Well Name: CANAL 20/19 FED COM	Well Location: T21S / R27E / SEC 20 / NENE / 32.4699353 / -104.2047142	County or Parish/State: EDDY / NM
Well Number: 853H	Type of Well: CONVENTIONAL GAS WELL	Allottee or Tribe Name:
Lease Number: NMNM0354232	Unit or CA Name:	Unit or CA Number:
US Well Number: 3001556355	Operator: MEWBOURNE OIL COMPANY

Notice of Intent

Sundry ID: 2864104

Procedure Description: Mewbourne Oil Company requests that the following changes be made to the Canal 20/19 Fed Com #853H (30-015-56355): • MOC requests to change the name of the Canal 20/19 Fed Com #853H to the Canal 20/19 Fed Com #853Y. • MOC requests to skid the Canal 20/19 Fed Com #853H f/ 1040 FNL & 355 FEL (20) to 940 FNL & 355 FEL (20). • Attached C-102 reflecting name change to Canal 20/19 Fed Com #853Y • Attached Dir Plan/Plot, Drlg Program, & C-102 reflecting requested changes to skid Canal 20/19 Fed Com #853H.

C-102 Submit Electronically Via OCD Permitting	State of New Mexico Energy, Minerals & Natural Resources Department OIL CONSERVATION DIVISION		Revised July 9, 2024	
	Submittal Type:	☐ Initial Submittal		
		☒ Amended Report		
		☐ As Drilled

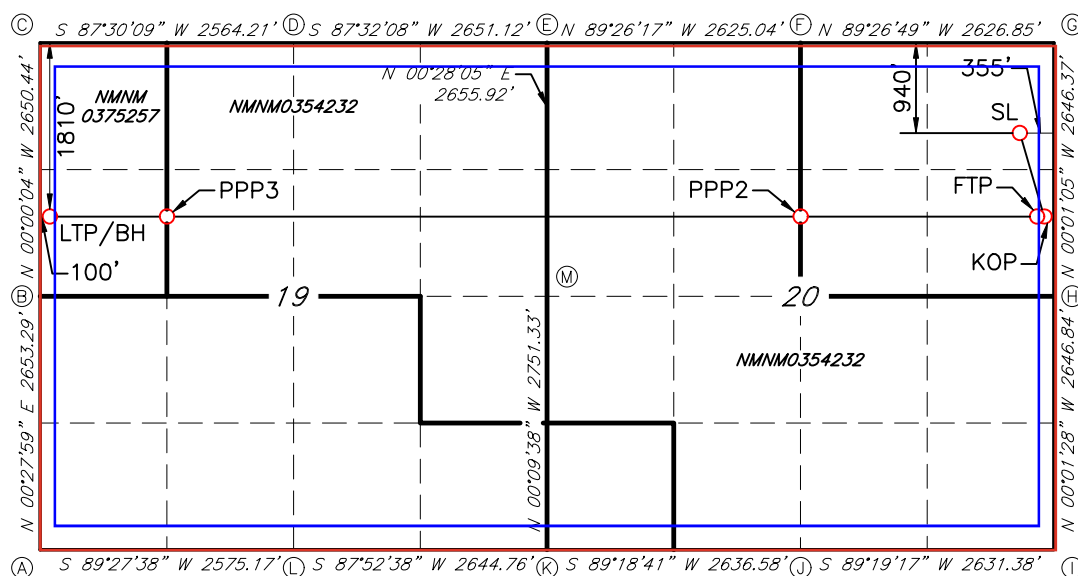
- MOC requests to change the name of the Canal 20/19 Fed Com #853H to the Canal 20/19 Fed Com #853Y.
- MOC requests to skid the Canal 20/19 Fed Com #853H f/ 1040 FNL & 355 FEL (20) to 940 FNL & 355 FEL (20).
- Attached C-102 reflecting name change to Canal 20/19 Fed Com #853Y
- Attached Dir Plan/Plot, Drlg Program, & C-102 reflecting requested changes to skid Canal 20/19 Fed Com #853H.

UL A	Section 20	Township 21S	Range 27E	Lot	Ft. from N/S 940 FNL	Ft. from E/W 355 FEL	Latitude 32.4702101°N	Longitude 104.2047139°W	County EDDY
----------------	----------------------	------------------------	---------------------	-----	--------------------------------	--------------------------------	---------------------------------	-----------------------------------	-----------------------
